# Avoid corrosion on blower shell holders

## Shell holders anti corrosion

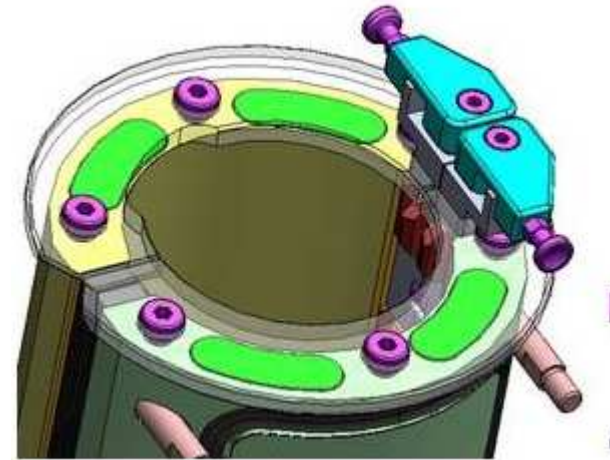
- No more corrosion effect due to better insulation
- No more water leaks
- Reduce maintenance costs due to shell holders replacement (because of corrosion)

- New design of the shell holders assembly
- Flat seals are replacing the current o-rings
